Application for Variation of an Environmental Permit

C1. Name of the Current Environmental Permit Holder :  
Water Supplies Department  
C2. Application No. of the Current Environmental Permit : EP-207/2005  
C3. The Current Environmental Permit was Issued in : month / year  
01 / 2005

### **Original Visual Screening Measure for SHW WTW Extension proposed in the EIA Report**

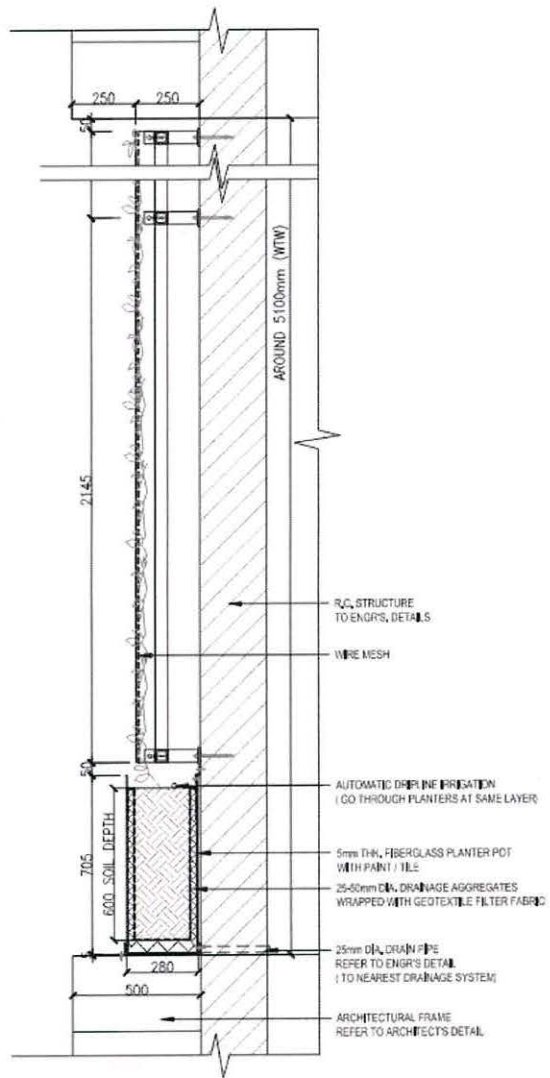
Instead of tree planting along the north-western site boundary of the SHW WTW, vertical greening (e.g. evergreen climbers and weeping plants) is proposed on the external wall of the new SHW WTW extension building to blend the building into the surrounding environment. Reference of the proposed vertical greening is provided in **Exhibit 1** and the perspective view (with and without proposed vertical greening) is shown in **Exhibit 2**. The details shown in **Exhibit 1** and **Exhibit 2** are tentative and will be subject to the detailed design of the vertical greening.

Exhibit 3 Photomontage of Selected Viewpoint (from Sham Shui Kok Drive)

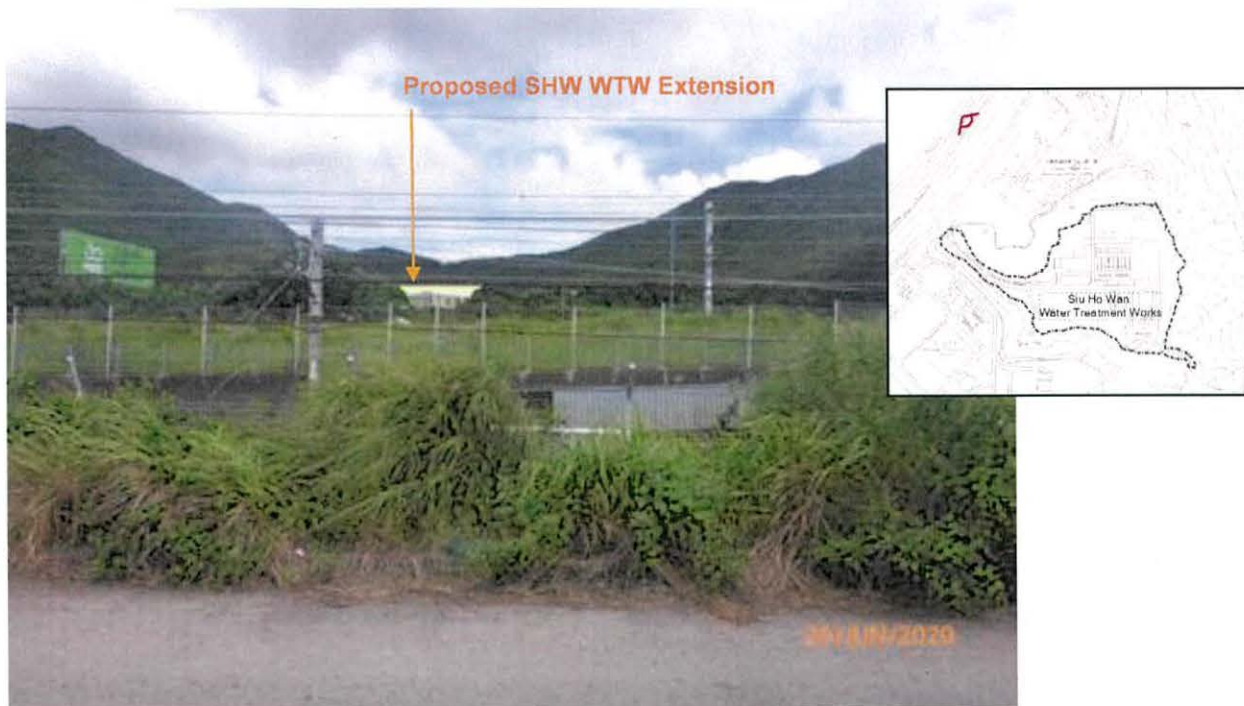
The photomontages of selected viewpoint (from Sham Shui Kok Drive) with and without visual impact mitigation measures including vertical greening are presented in **Exhibit 3**.
